DART AEROSPACE LTD	Work Order:	157848
Description: Crosstube Assembly	Part Number:	D407-667-145
Inspection Dwg: D407-667-145 Rev: C		Page 1 of 2

DESIGN	9	DART AEROSPACE LTD	
DRAWN	RF	HAWKESBURY, ONTARIO, CANADA	
CHECKED	CP	DRAWING NO.	REV. C
MFG. APPR.	CP	D407-667-145	SHEET 4 OF 4
APPROVED	CP	TITLE	SCALE
DE APPR.	CP	CROSSTUBE ASSY (407 HIGH FWD)	NTS
DATE	08.11.06	COPYRIGHT © 2002 BY DART AEROSPACE LTD	
THIS DOCUMENT IS PRIVATE AND CONFIDENTIAL, AND IS SUPPLIED ON THE EXPRESS CONDITION THAT IT IS NOT TO BE USED FOR ANY PURPOSE OR COMMUNICATED TO ANY OTHER PERSON WITHOUT WRITTEN PERMISSION FROM DART AEROSPACE LTD.

DRAWING NO. D407-667-145	TITLE CROSSTUBE ASS'Y (407 HIGH FWD)	REV. C	DART AEROSPACE LTD ENGINEERING ORDER		D.E.O. NO. D407-667-145-C-1	SHEET NO. SHEET 1 OF 1	SCALE NTS
DRAWN qp	CHECKED ASS	MFG. APPR. iB	APPROVED WD		DE APPR. H		
DATE 11.07.15	DATE 11.07.22	DATE 11.07.22	DATE 11/07/22		DATE 11.07.21

DRAWING NO. D407-667-145	TITLE CROSSTUBE ASS'Y (407 HIGH FWD)	REV. C	DART AEROSPACE LTD ENGINEERING ORDER		D.E.O. NO. D407-667-145-C-2	SHEET NO. SHEET 1 OF 1	SCALE NTS
DRAWN AJS	CHECKED <i>[Signature]</i>	MFG. APPR. <i>[Signature]</i>	APPROVED <i>[Signature]</i>		DE APPR. <i>[

DETAIL P
BONDING STRAP INSTALLATION 2 PL

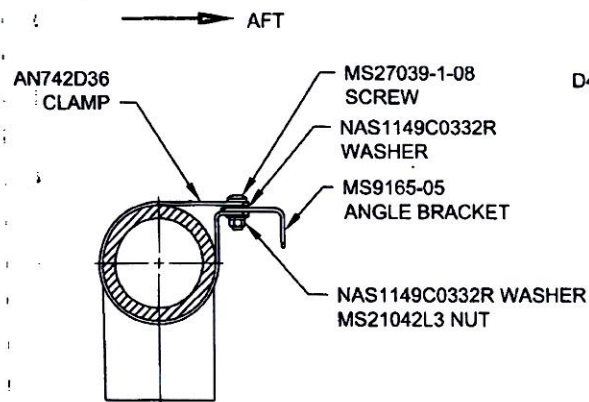
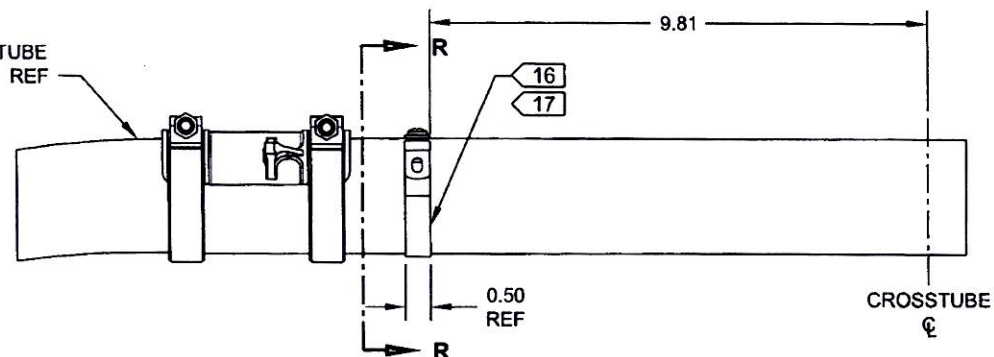
ADD ELECTRICAL GROUNDING STRAP

ITEM	QTY	PART NUMBER	DESCRIPTION
1	X	D407-667-145	CROSSTUBE ASSEMBLY (407 HIGH FWD)
10	2	AN742D36	CLAMP
11	2	MS9165-05	ANGLE BRACKET
12	2	MS21042L3	NUT (OR MS21042-3)
13	2	MS27039-1-08	SCREW
14	4	NAS1149C0332R	WASHER (OR AN960C10L)

- 16) MASK AREA UNDER CLAMP PRIOR TO PAINTING
- 17) SEAL EDGES WHERE AN742D36 CLAMP MEETS WITH THE CROSSTUBE USING SIKAFLEX-241/-291 OR MIL-S-8802 CLASS B2 OR PROSEAL 890 SEALANT
- 18) PERFORM RESISTANCE CHECK TO ENSURE MAX RESISTANCE IS 10 MILLIOHMS
